AMENDMENT NO. 4 OCTOBER 2016
TO
IS 15476 : 2004 BAMBOO MAT CORRUGATED SHEETS —
SPECIFICATION

Amendment No. 4 to IS 15476 : 2004

FIG. 1A PITCH AND DEPTH OF CORRUGATED SHEETS

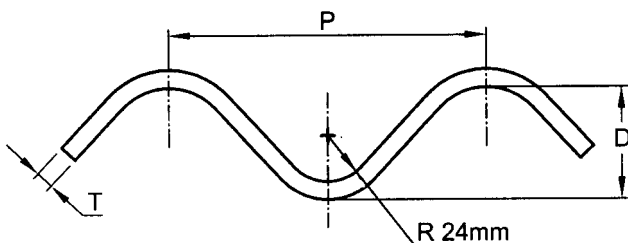
(Page 1, clause 6.1, line 2) — Substitute ‘Fig. 1A’ for ‘Fig. 1’.

(Page 2, Fig. 1) — Substitute the following new figure for the existing figure:

FIG. 1B A TYPICAL RIDGE CAP AND ITS DIMENSIONS

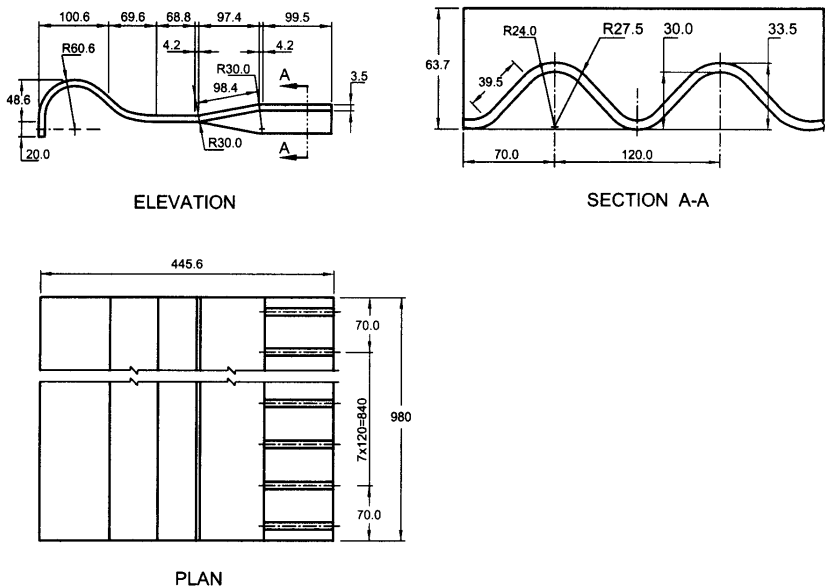
‘6.2 The length and width of the ridge caps shall be of size 430 mm and 1 050 mm respectively with tolerances of ± 10 mm and the thickness shall be $3.8 \text{ mm} \pm 10\%$. The ridge caps shall conform to the dimensions given in Fig. 1B.’
